Luminant

CP-201201129
TXX-12139

SUBJECT: COMANCHE PEAK NUCLEAR POWER PLANT (CPNPP) DOCKET NOS. 50-445 AND 50-446, LICENSE AMENDMENT REQUEST (LAR) 12-005, REVISION TO TECHNICAL SPECIFICATIONS 3.3.1, "REACTOR TRIP SYSTEM (RTS) INSTRUMENTATION" AND 3.3.2, "ENGINEERED SAFETY FEATURE ACTUATION SYSTEM (ESFAS) INSTRUMENTATION."

Table 3.3.1-1 (page 3 of 6)
Reactor Trip System Instrumentation

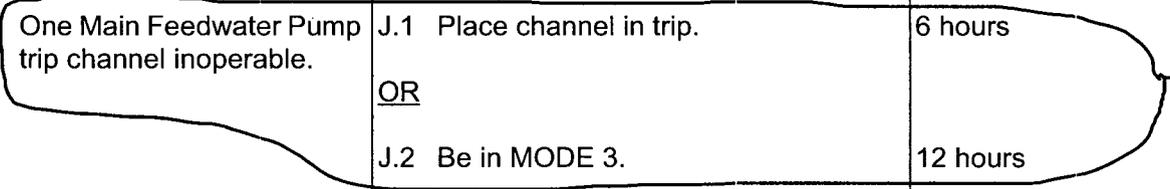
The proposed change would revise TS 3.3.1, "Reactor Trip System (RTS) Instrumentation" to relocate the requirements for the reactor trip on Pressurizer Water Level - High (RTS Function Number 9 on TS Table 3.3.1-1) from the TS and TS 3.3.2, "Engineered Safety Feature Actuation System (ESFAS) Instrumentation" to relocate the requirements for the Auxiliary Feedwater (AFW) System start on "Trip of all Main Feedwater Pumps" (ESFAS Function Number 6.g on TS Table 3.3.2-1) and the ESFAS Interlock "Reactor Trip, P-4" (ESFAS Function Number 8.a on TS Table 3.3.2-1) from the TS. The affected RTS and ESFAS requirements would be relocated in their entirety to the Technical Requirements Manual, a licensee document controlled under 10CFR50.59.
